### **Annual Review of Portage and Goose Pit Slope Performance**

# 2016 ANNUAL PIT SLOPE PERFORMANCE REVIEW MEADOWBANK MINE, NUNAVUT

DECEMBER 21, 2016

ISSUED FOR USE  
704-ENG. EARC03050-01

Photograph 4-4: Pit A lower west wall raveling

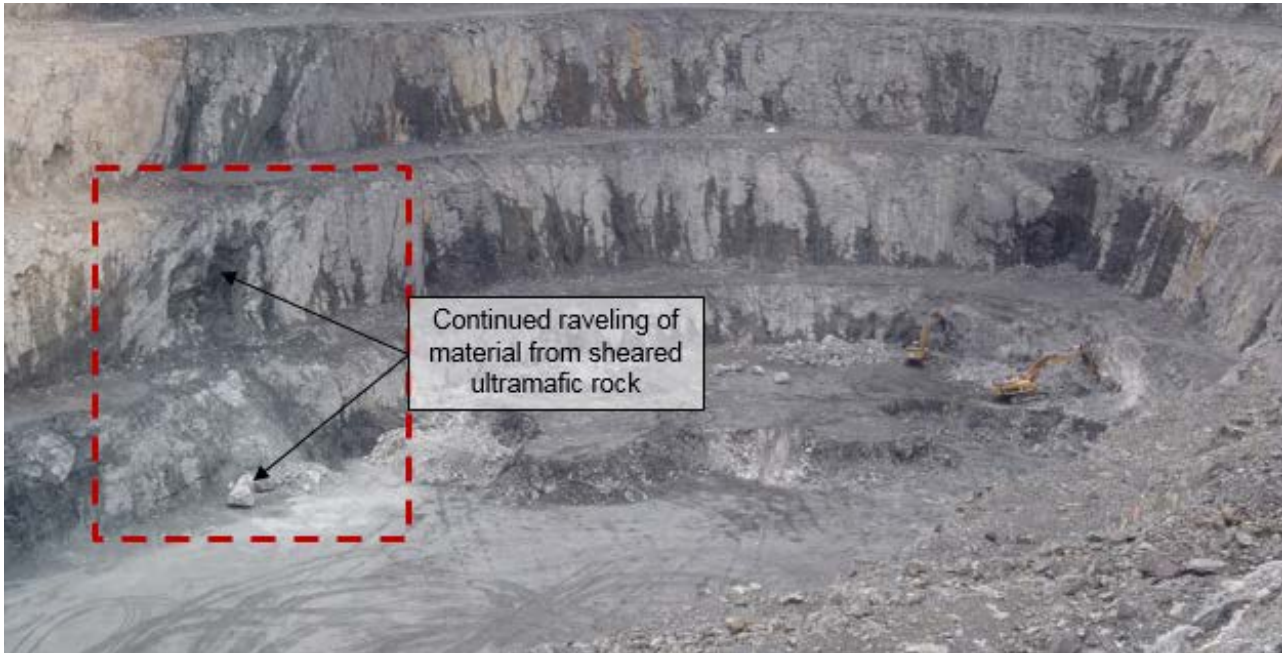
An area of instability of the lower west wall observed during the 2014 inspection continues to ravel, and some new material has accumulated at the toe of the slope (shown in Photograph 4-3, Photograph 4-4, and Photograph 4-5). A hard toe in iron formation remains at the base of the slope, undercutting out-dipping planes. Poor quality and strongly sheared ultramafic rock between quartzite and iron formation continues to ravel. More ultramafic rock has been exposed along the lowermost bench because of mining down of the pushback area. This has resulted in loss of catchment locally.

These are bench scale occurrences and not indicative of larger scale instability, hence can be managed through mucking as necessary. However, due to the poor quality of the ultramafic rock a bumper berm should be

constructed at the toe of the slope beneath the ultramafic rock to restrict runout of any additional material that might ravel from this area, and to restrict access by personnel or equipment in this area.

- Remove boulder, then construct bumper berm adjacent to toe of slope to restrict access and to collect any additional material that might ravel.
- Continue visual monitoring and recording observations as part of regular site geotechnical inspections.

Photograph 4-7: Pit A 5109 bench instability 2012 and 2016

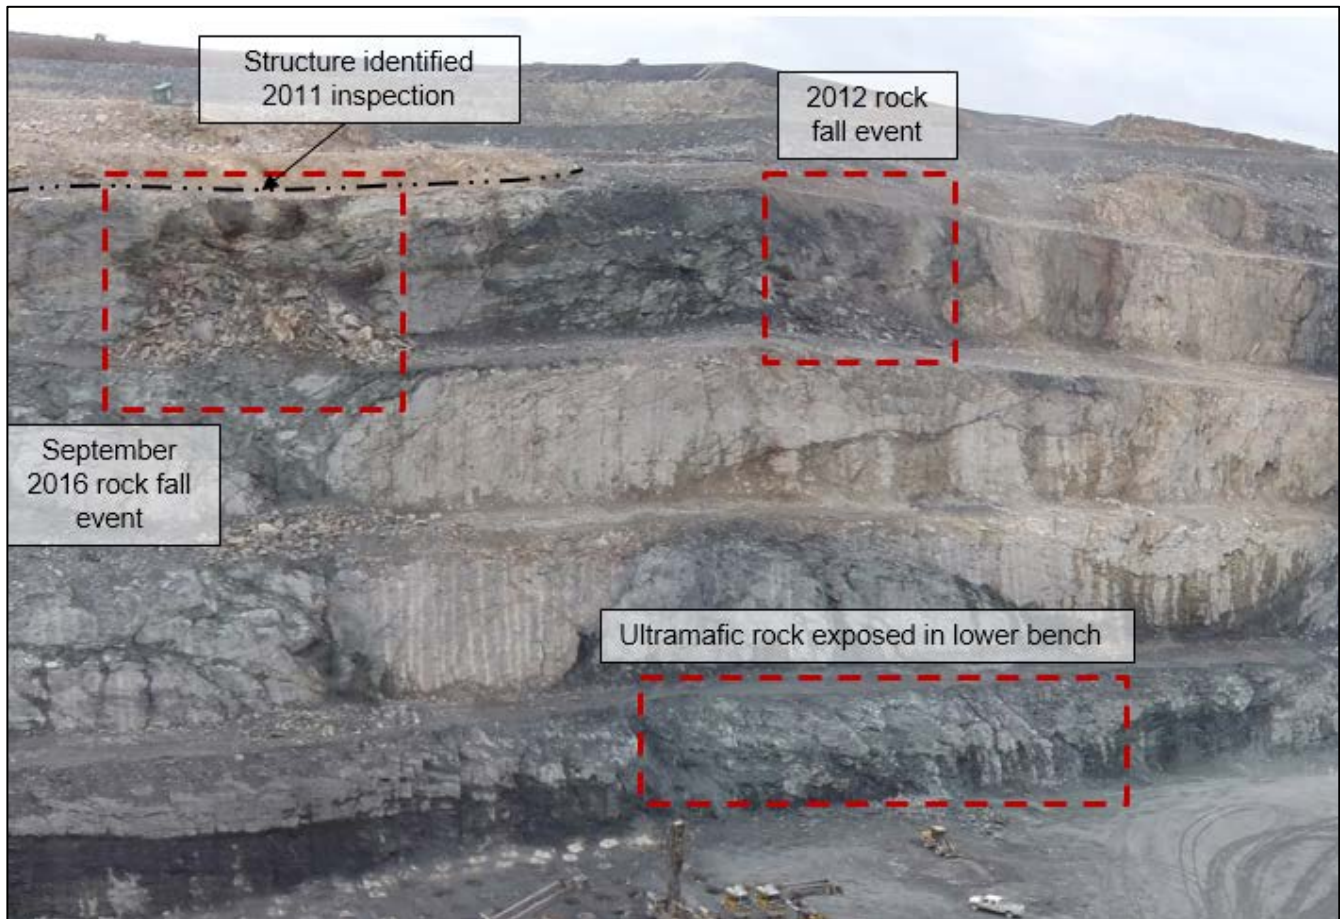
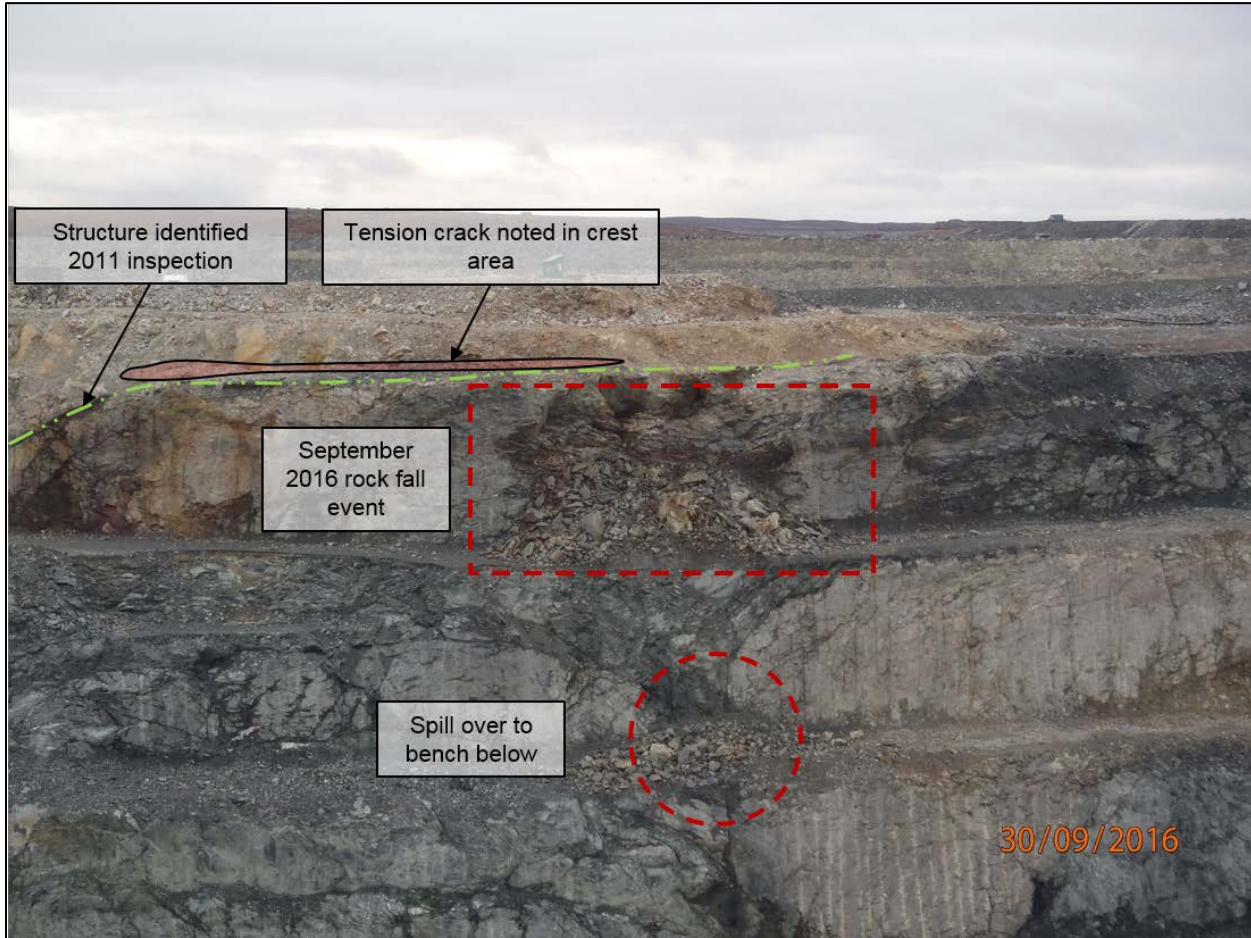
A rock fall event from 2012 along the west wall of Pit A continues to be monitored. The location is shown on the following photograph. The geological structure and rock mass quality that contributed to the 2012 rock fall event has also contributed to the rock fall event in September 2016.

The 2012 bench-scale instability is a result of complex folding and shearing of the stratigraphy in this area. Contributing to the raveling of material is a structure behind the wall dipping at a relatively steep angle to the west. This provides a back-release surface to allow toppling and raveling of the poor-quality rock. Previously the ramp access to Pit A traversed beneath this area and the area was monitored on an on-going basis with restricted access to the area through the use of berms to prevent bench access.

A rock fall event occurred on 26 September 2016 on the 5109 bench of the west wall of Pit A. The area is shown in Photograph 4-6 above. The volume of failed material is estimated by AEM at 1,500 m<sup>3</sup>. The rock fall occurred following a pit blast, and some material spilled over on to the 2 benches below. The contributing factors appear to be the following:

Photograph 4-12: Voids in quartzite above Pit A west ramp (2016)

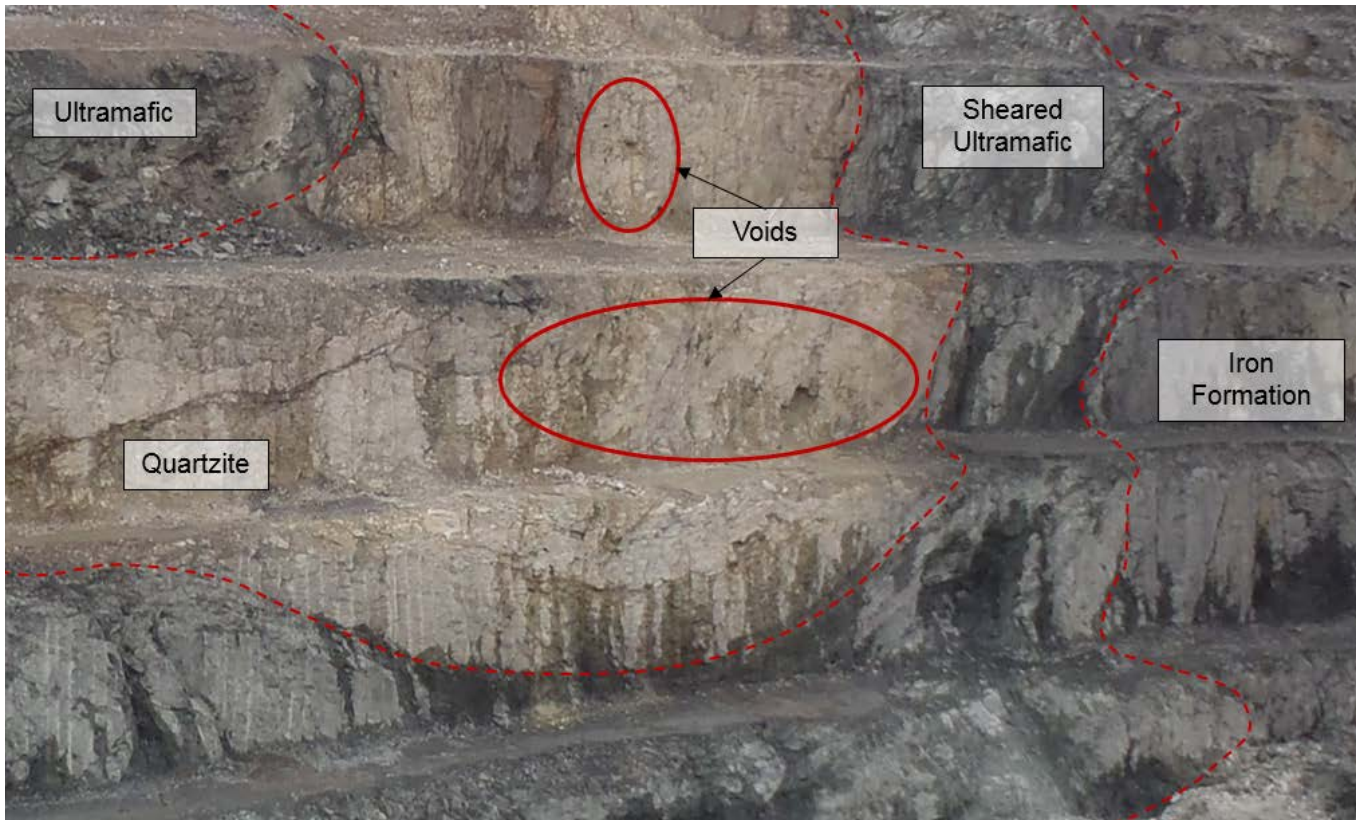
The quartzite stratigraphy observed in the Pit A west wall contains several large voids identified during previous inspections. These have been the source of local raveling, and previously the ramp access to the pit passed beneath these. The ramp access has since been removed, and raveling of rock from these areas no longer presents a hazard as material will be retained on the catch benches.

Figure 4-1: Small wedge above stockpiled material

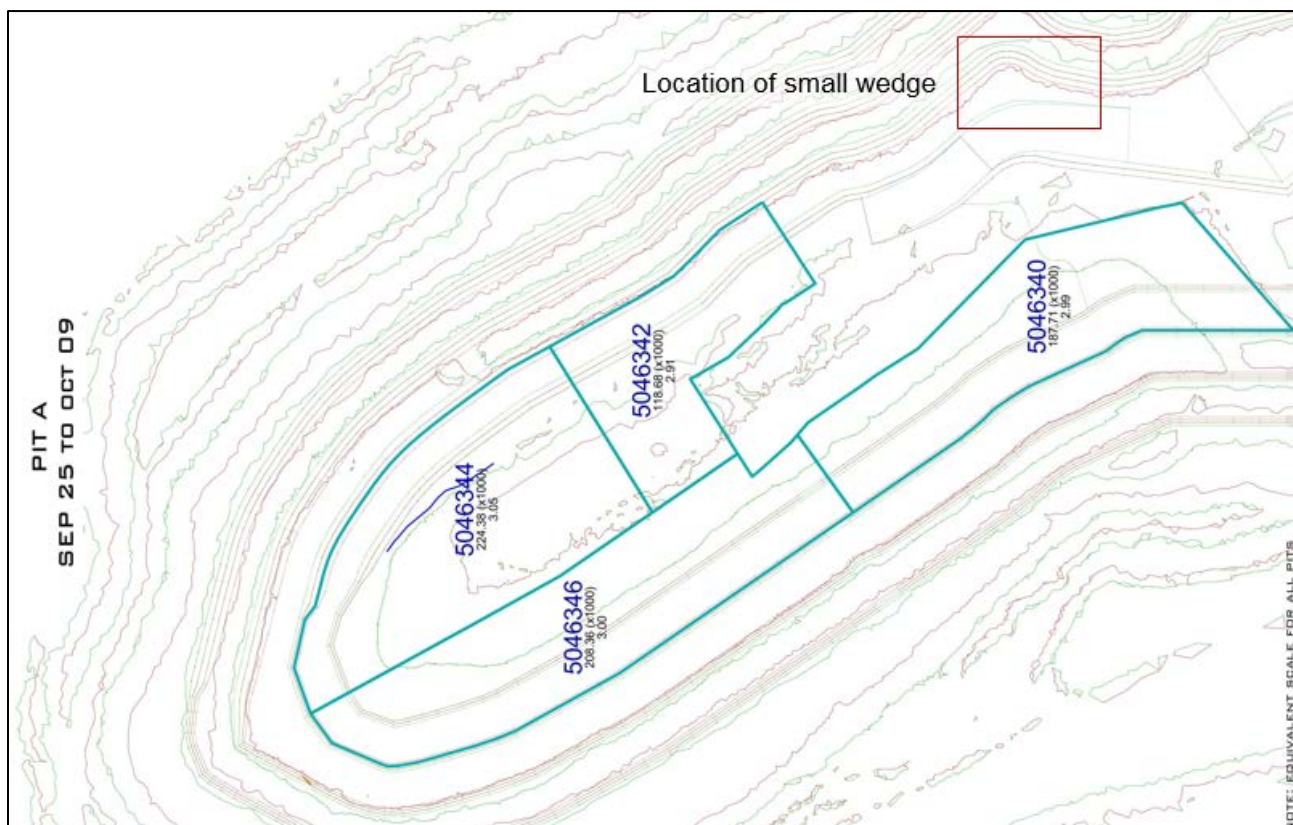
The northwest through northeast end walls and the east wall continue to perform well. A small wedge was noted above a stockpile located on the east wall ramp. It was recommended this be removed and that a bumper berm be placed to prevent personnel and equipment from entering under the wedge location.

During the site visit, a small wedge was observed in the transition from the Pit A east wall to Pit B east wall. The location is shown in the following figure.

Photograph 6-12: Pit E3 Ramp Areas 4 and 5 viewed from the ramp (from 2015 inspection)

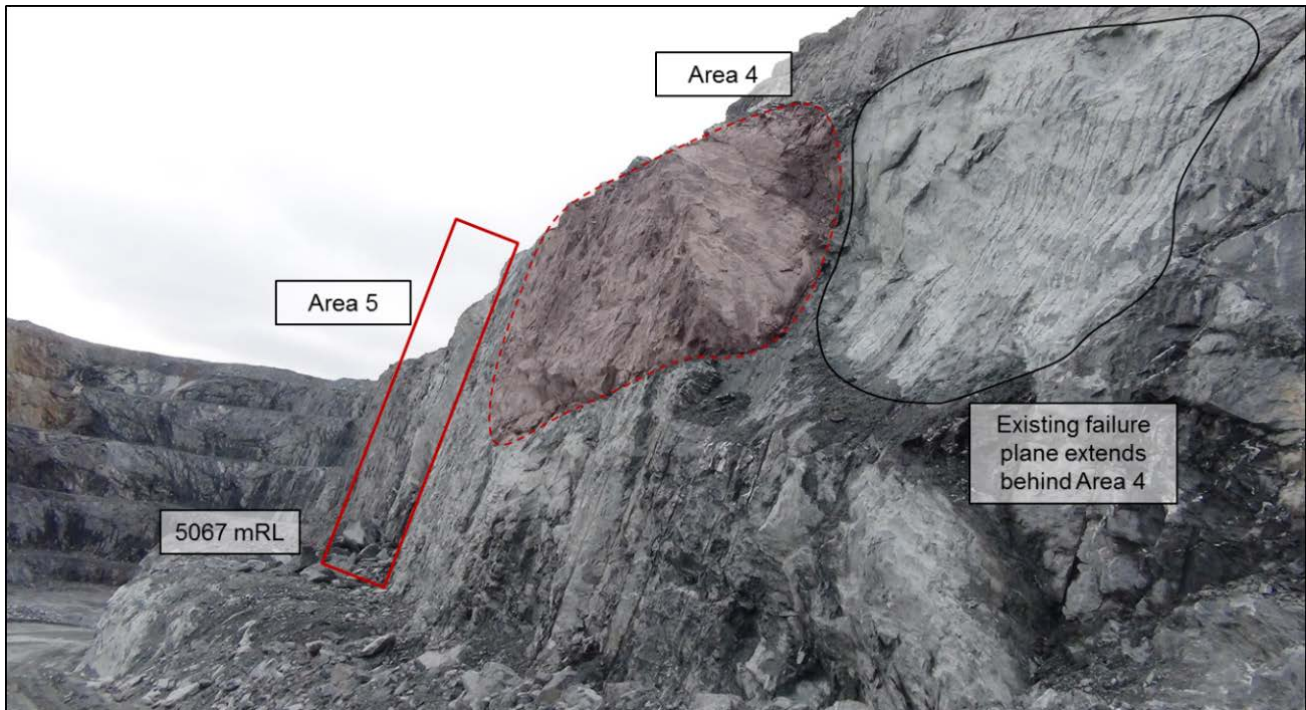
Area 4 is a potential planar failure formed by a steep east dipping sliding plane undercut by the bench face. The sliding plane is exposed adjacent to Area 4 on a portion of wall that was removed through scaling. The plane extends behind the Area 4 block, and daylight in the bench face. The rock fall containment berm on the west ramp extends beneath the rock block to manage the risk associated with the potential failure of this material.

No new material was observed to have failed on to the 5067 bench since the 2015 inspection. However, it is possible that some opening of the plane behind the Area 4 block has occurred; this block should continue to be monitored as part of the regular site geotechnical inspections.

Figure 6-2: Area 7 instability at base of Pit E3 ramp

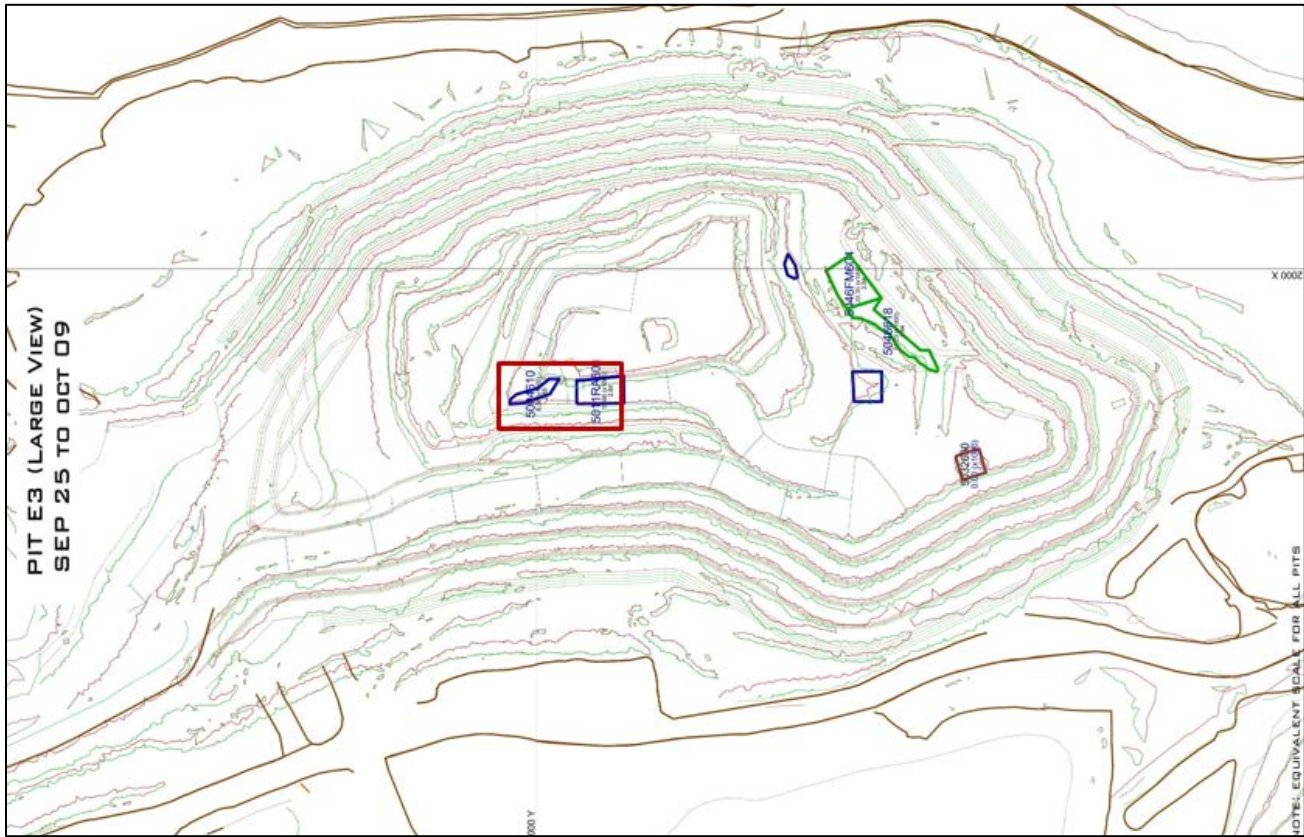
A seventh area of potential instability was identified during the 2016 inspection. The area is at the base of the ramp, on the north side of the pit, and near the contact between iron formation and ultramafic rock. The location is shown on the following figure.

The potential instability is characterized by strongly sheared ultramafic rock in contact with iron formation, with associated shear planes dipping out of the bench face. Some of the sheared planes are open. The geometry is to

A seventh potential area of instability was identified during the 2016 inspection. The area is at the base of the ramp, on the west and north side of the pit, and near the contact between iron formation and ultramafic rock. The ultramafic rock has been strongly sheared and faulted. Some of the sheared planes are open. The geometry and rock type is similar to the instability that was encountered adjacent to the ramp in the Goose Pit in 2014. As a preventive measure, and to avoid production delays that could result from local instability of the ultramafic rock on this bench, it was recommended to AEM during the site visit to investigate widening the ramp in this area. A safety berm should be constructed along this section of ramp to prevent personnel and equipment from stopping beneath this face.

Figure 7-1: Goose Pit location of instrumentation

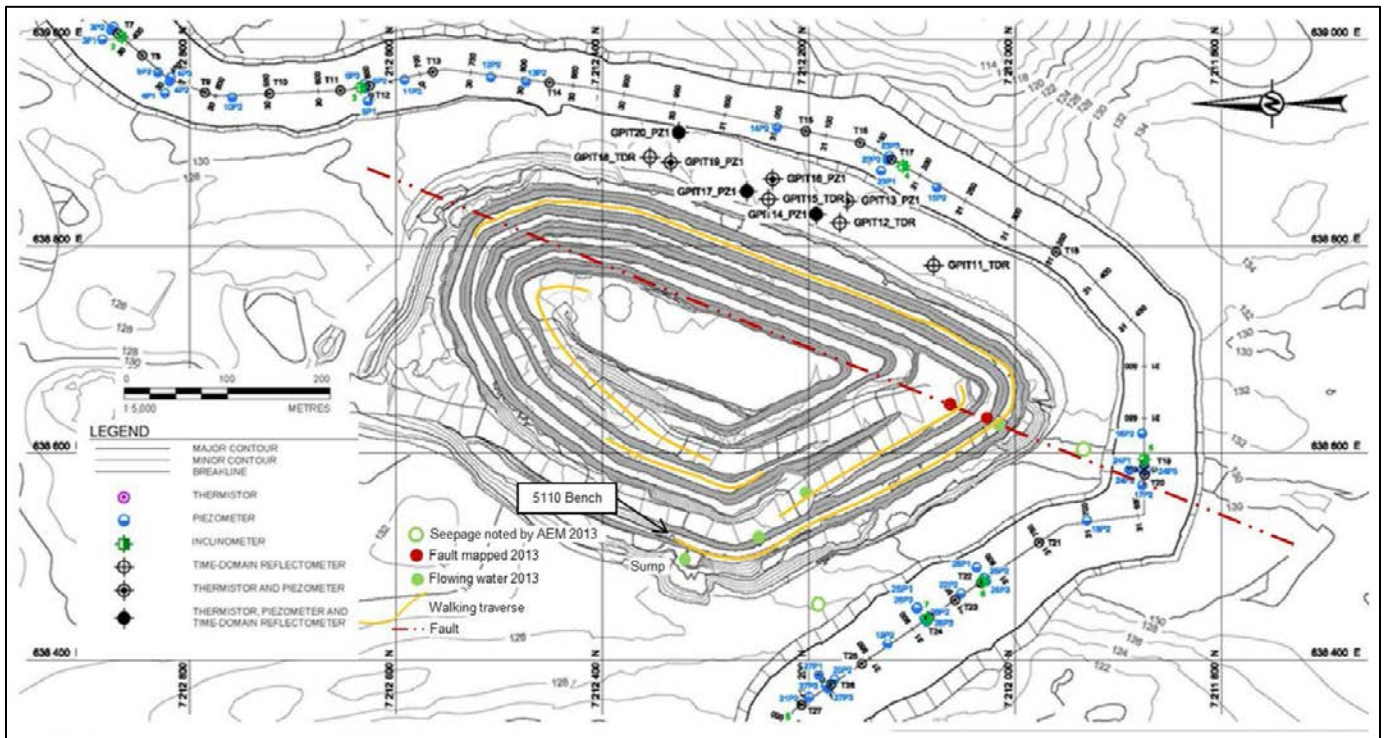
Seven TDR cables were installed in geotechnical boreholes drilled behind the east wall of the Goose pit in 2013 to monitor slope movement. A review of the data indicates no slope displacement. There is no noticeable change in the TDR cable signatures from 2015. The response for TDR GPIT-14 is erratic, suggesting it is damaged. There are no other indicators in the area to suggest slope movement.

Thermistors were installed in 6 geotechnical boreholes drilled behind the east wall in 2013. A review of the data indicates no significant change from 2015. The data indicate generally steady-state conditions have been reached.

Piezometers were installed in 6 geotechnical boreholes drilled behind the east wall in 2013. A review of the data indicates constant hydraulic heads, and no significant change from 2015. The exception is piezometer tip PZ4c in GPIT-14 which showed a decrease in hydraulic head from about 5043 m to about 4980 m from January to November 2016. This is similar to responses noted in 2015 and suggests this piezometer tip is damaged.

*Photograph 8-20: Crest loss on north transition wall*

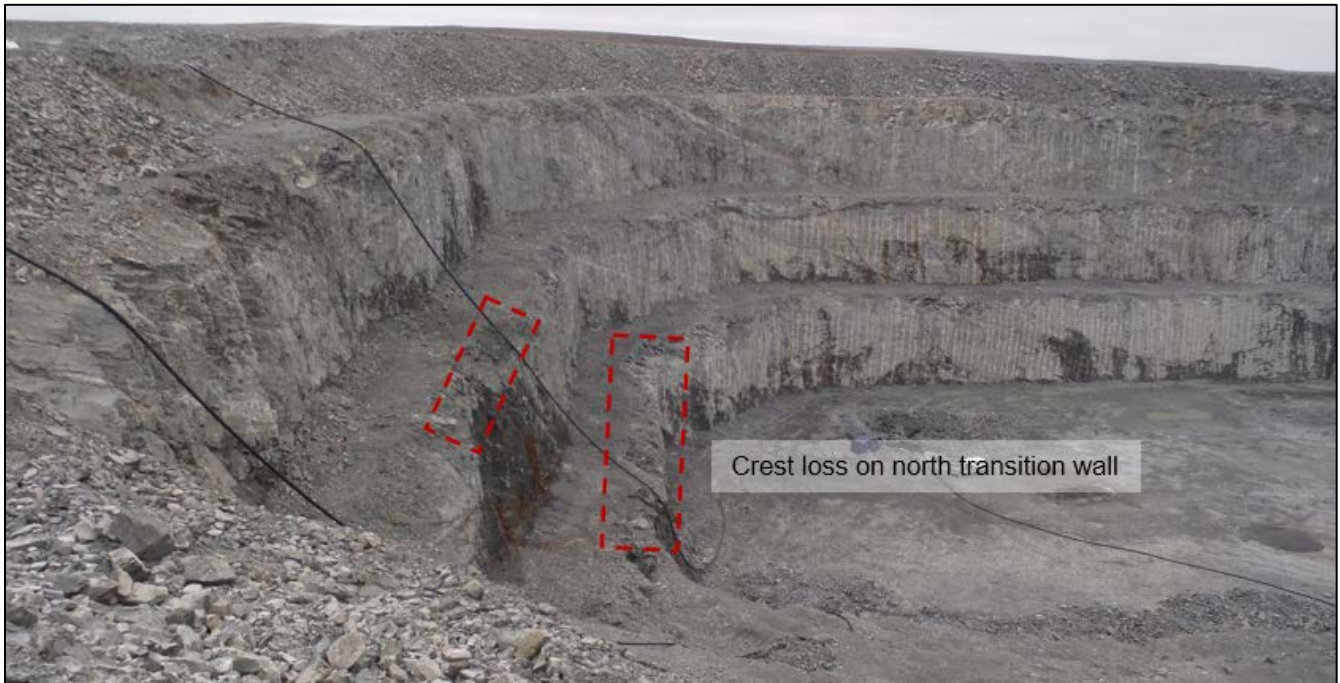
The local crest loss along the north transition wall is related to the change of wall orientation relative to the southeast dipping foliation, and its intersection with steeply northeast dipping joint planes. The joint planes provide a release surface for block sliding along the foliation.

The crest loss and block instability along the north wall was discussed with AEM during the site inspection, and it was recommended that a bumper berm be placed along the toe of the north wall to retain any material raveling from the benches, and to prevent equipment and personnel from approaching this area. The hard toe at the northwest corner will remain in place as there is a 20 m step-in catch bench planned at this level.
